## Addendum One

CLUBHOUSE ROOF REPLACEMENT  
 ATWOOD HOMESTEAD FOREST PRESERVE  
 8990 OLD RIVER ROAD MACHESNEY PARK, IL 61103

## PLAN - CLUBHOUSE ROOF

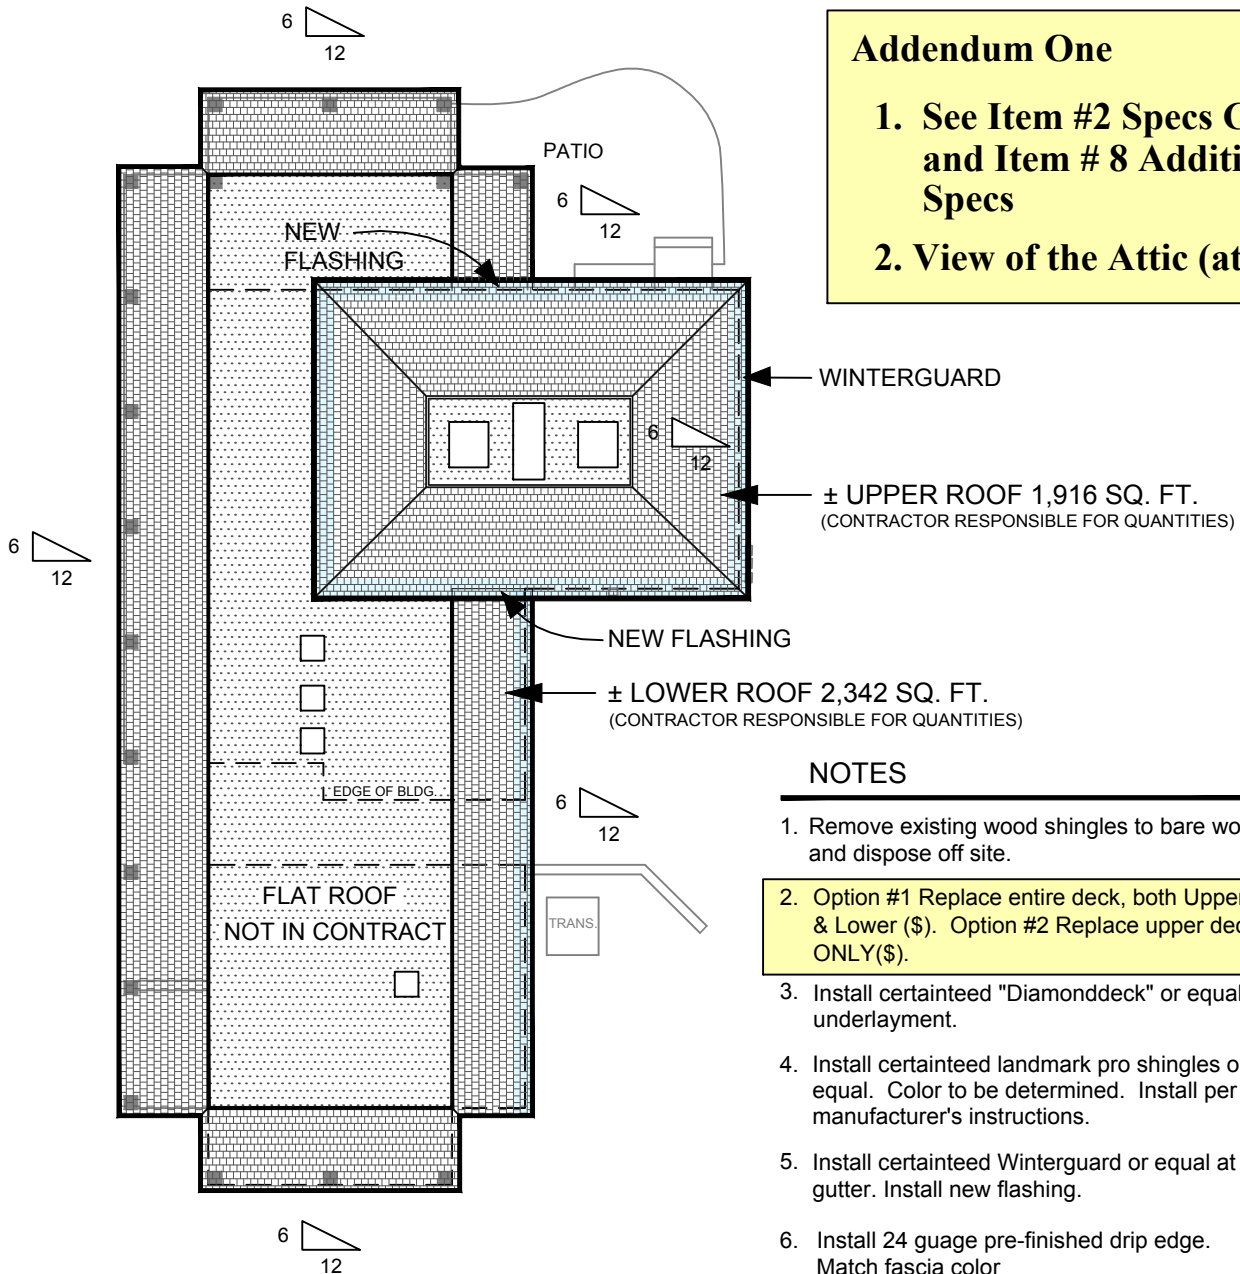
1. See Item #2 Specs Change and Item # 8 Additional Specs
2. View of the Attic (attached)

8. Add boxed roof vents to the following locations:
  - Northside Quantity: 3
  - Southside Quantity: 3
  - Eastside Quantity: 2
  - Westside Quantity: 2
